NRC RAI Letter No. PTN-RAI-LTR-041

SRP Section: 02.05.01 - Basic Geologic and Seismic Information

NRC RAI Number: 02.05.01-17 (eRAI 6024)

Proposed Turkey Point Units 6 and 7

Figure 2 Structure Contour Map of the Top of the Key Largo Limestone

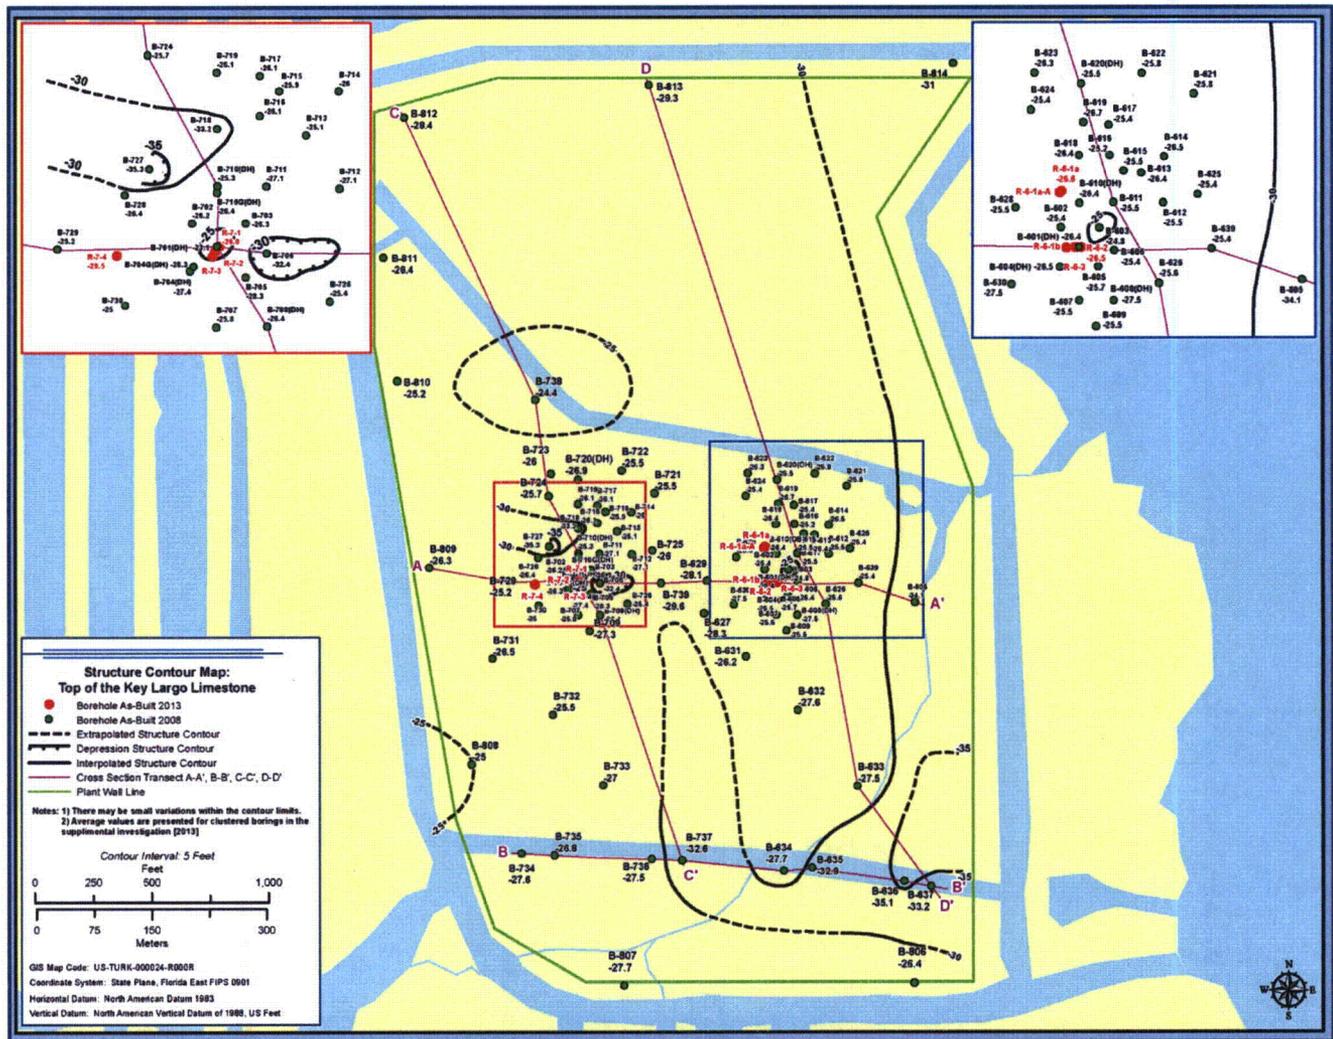
- a) Indicate the elevation on the structure contour maps and thickness values on the isopachs.
- b) Indicate thin areas on the isopachs and low areas on structure contours.
- c) Plot the location of cross section lines A, B, C, and D on the isopach and structure contour maps.
- d) Provide a structure contour for the Key Largo formation.
- e) The FSAR describes the Fort Thompson Formation as vuggy, and solution riddled. In light of this characteristic in the underlying Fort Thompson, discuss the implication of the numerous closed circles shown on the Key Largo isopach.

d) Provide a structure contour for the Key Largo formation.

Revised structure contour maps showing the elevations of the top of the Fort Thompson Formation and the top of the Key Largo Limestone are provided in Figures 1 and 2, respectively. Revised isopach maps including thickness values of the Fort Thompson Formation and the Key Largo Limestone are provided in Figures 3 and 4.

A relatively thin area in the Fort Thompson Formation is shown on Figure 3 in the vicinity of boring B-805. Relatively thin areas in the Key Largo Limestone are shown on Figure 4 in the vicinity of borings B-636, B-727, and B-737. Relatively low areas in the top of the Fort Thompson Formation are shown on Figure 1 in the vicinity of borings B-625, B-634, B-712, and B-728. Relatively low areas in the top of the Key Largo Limestone are shown on Figure 2 in the vicinity of borings B-636, B-706, and B-727, B-737, and B-738.

A structure contour map of the top of the Key Largo Limestone is provided in Figure 2.

Similarly, there does not appear to be a strong correlation between Figure 1 and Figure 2 (Structure Contour Map of the Top of the Key Largo Limestone). Although both maps show a depression in the area of soil boring B-727, the topographic relief within the depression on the surface of the Fort Thompson Formation in this area is approximately 2.5 feet (0.8 meters), whereas the topographic relief in the depression on the surface of the overlying Key Largo Limestone in the same area is approximately 10 feet (3 meters). It seems unlikely that subsidence of about 2.5 feet (0.8 meters) in the Fort Thompson Formation due to collapse of a hypothetical solution cavity would induce corresponding subsidence of about 10 (3 meters) feet in the Key Largo Limestone.

The structure contour map of the top of the Key Largo Limestone (Figure 2) does not correlate strongly with the locations of the vegetated depressions ("mangroves" on FSAR Figure 2.5.4-223) onsite. This finding suggests that the dissolution that has occurred within and beneath these vegetated depressions has not greatly affected the top of the Key Largo Limestone.

The probable origin of the depressions on the top of the Key Largo Limestone (Figure 2) is deposition that was influenced by paleodrainage features in the underlying Fort Thompson Formation. The depressions may also reflect restricted areas where syndepositional erosion or relatively little deposition occurred within a shallow patch reef environment.

Figure 4 Isopach Map of the Key Largo Limestone

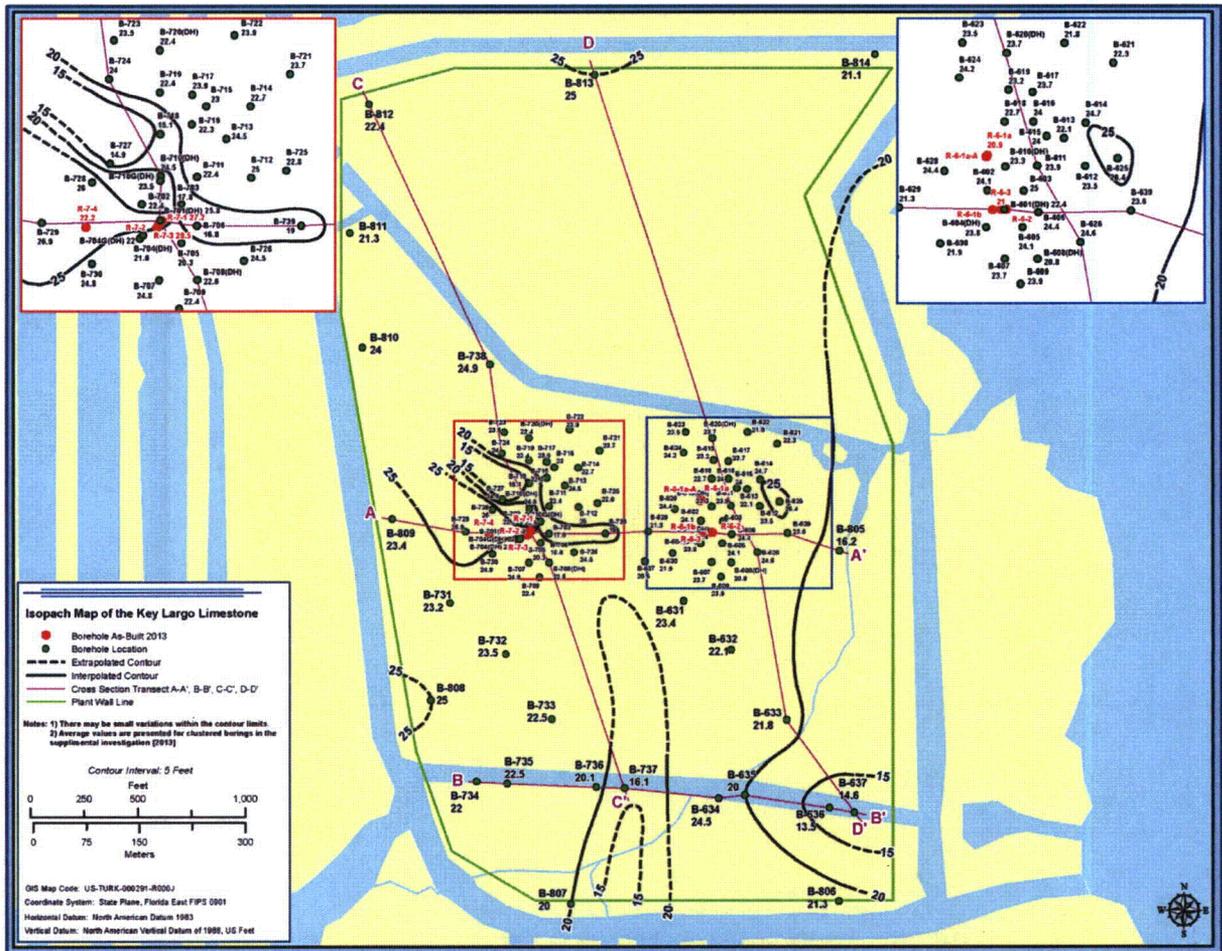
e) The FSAR describes the Fort Thompson Formation as vuggy, and solution-riddled. In light of this characteristic in the underlying Fort Thompson, discuss the implication of the numerous closed circles shown on the Key Largo isopach.

Comparison of Figure 4 (Isopach Map of the Key Largo Limestone) and Figure 1 (Structure Contour Map of the Top of the Fort Thompson Formation) suggests that there is no strong correlation between the thickness of the Key Largo Limestone and the topography at the top of the Fort Thompson Formation. There are no co-located and similarly oriented closed-contour depressions on the two maps. This observation suggests the absence of a large collapse feature within the Fort Thompson Formation that extends upward into the Key Largo Limestone. The broad depressions with 2 to 3 feet (0.6 to 0.9 meters) of relief shown on the top of the Fort Thompson Formation in the vicinity of borings B-634 and B-729 (Figure 1) may be an expression of paleodrainage. That paleodrainage may be reflected in the broad relatively thin zones in the same areas of the Key Largo Limestone shown on Figure 4. This relationship may be a reflection of the underlying topography on which the Key Largo Limestone was deposited.

It can be noted that, with one exception, in the few instances where closed-contour depressions have been mapped on the structure contour and isopach maps the topographic relief within the depressions is no more than one or two feet (0.3 to 0.6 meters). This observation suggests that the topography of the top surface of both the Key Largo Limestone and Fort Thompson Formation is relatively flat. The one exception is on the top of the Key Largo Limestone (Figure 2) in the vicinity of boring B-706, where the topographic relief is approximately 6 feet (1.8 meters). Comparison with the isopach map of the Key Largo Limestone (Figure 4) reveals that boring B-706 is within a broad area of thinning of the unit that may be an expression of paleodrainage.
